Release Notes

Product Name: VIA

Type	Number	Date
Firmware	4.0.3.1351	November 2023
Software	–	–
Web	–	–
Hardware	–	–

RN Date: November 22, 2023

Re-install the client app

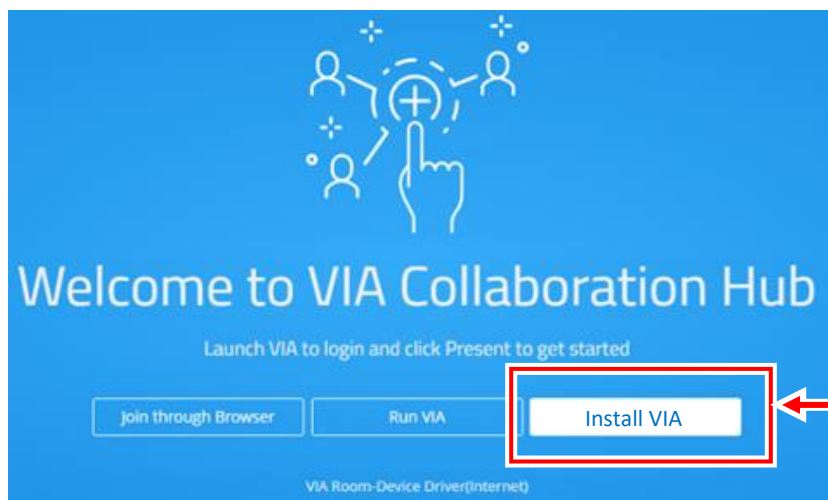
- HTTPS MUST be used to connect to the Gateway device: HTTP is no longer supported. Enter [https//x.x.x.x](https://x.x.x.x).
- The VIA Client app MUST be updated from the Gateway Login page, see the image below.
